MICHIGAN
DEPARTMENT OF CONSERVATION
PARKS AND RECREATION DIVISION

ALOHA STATE PARK
BOAT BASIN EXCAVATION
STOCKPILES

PLAN NO. WORK SHEET

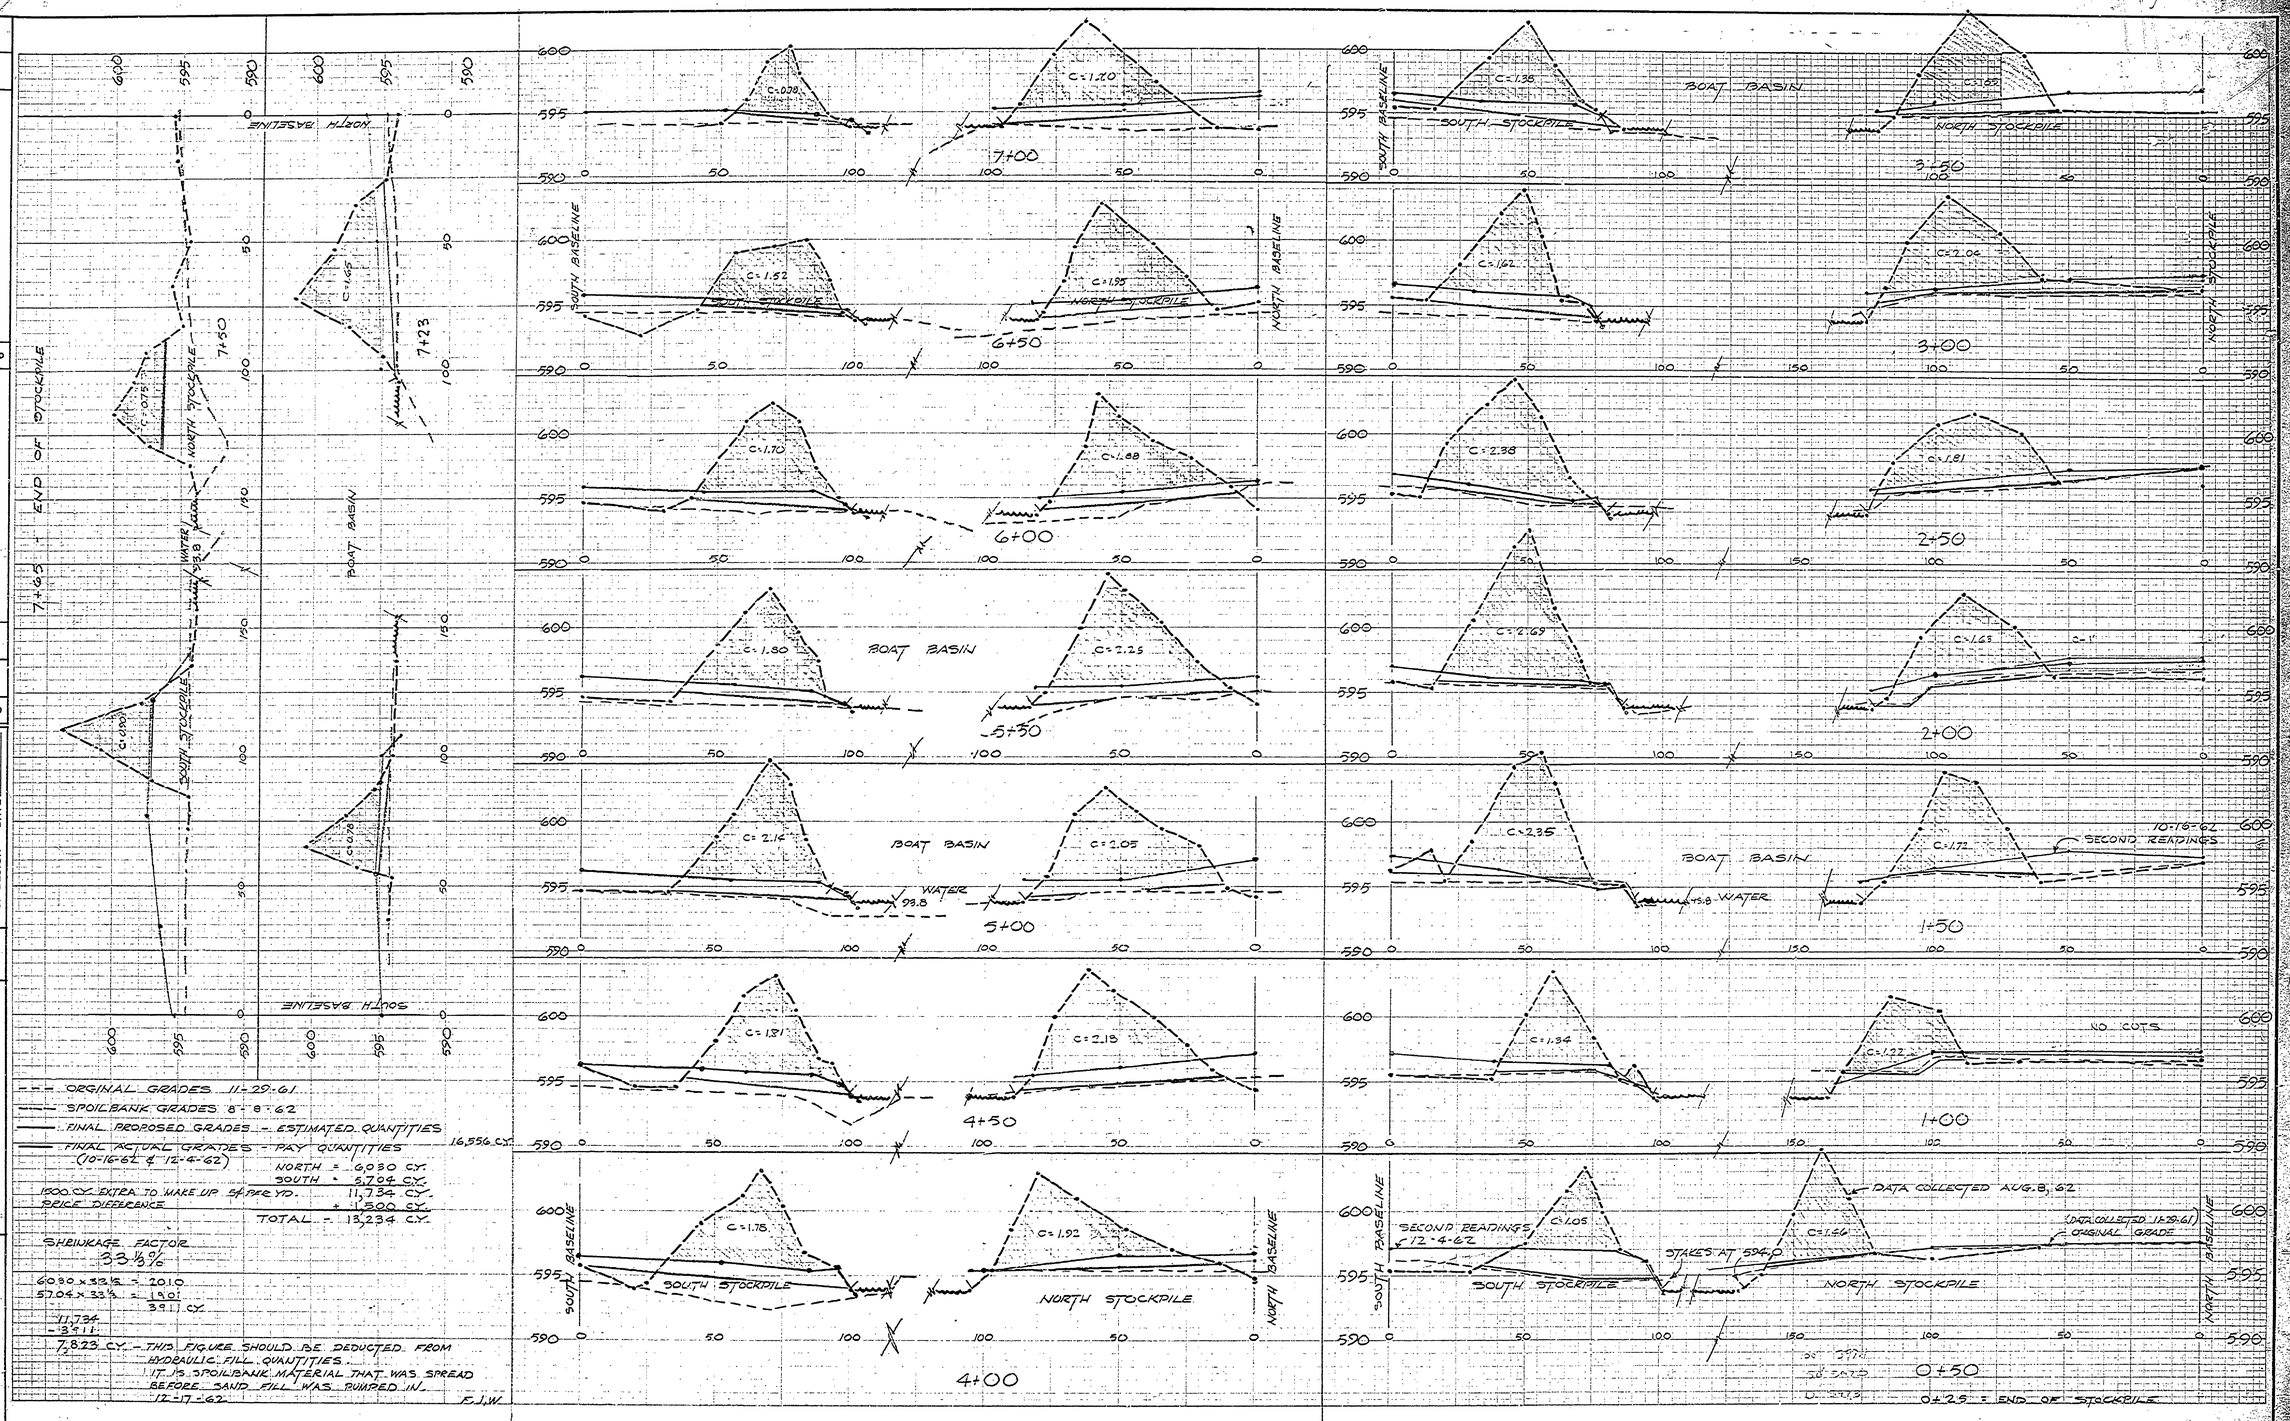
6030 × 33⅓ = 2010
5704 × 33⅓ = 1901
3911 CY
11,734
- 3911
7,823 CY. - THIS FIGURE SHOULD BE DEDUCTED FROM HYDRAULIC FILL QUANTITIES.
IT IS SPOILBANK MATERIAL THAT WAS SPREAD BEFORE SAND FILL WAS PUMPED IN.
12-17-62 F.J.W.
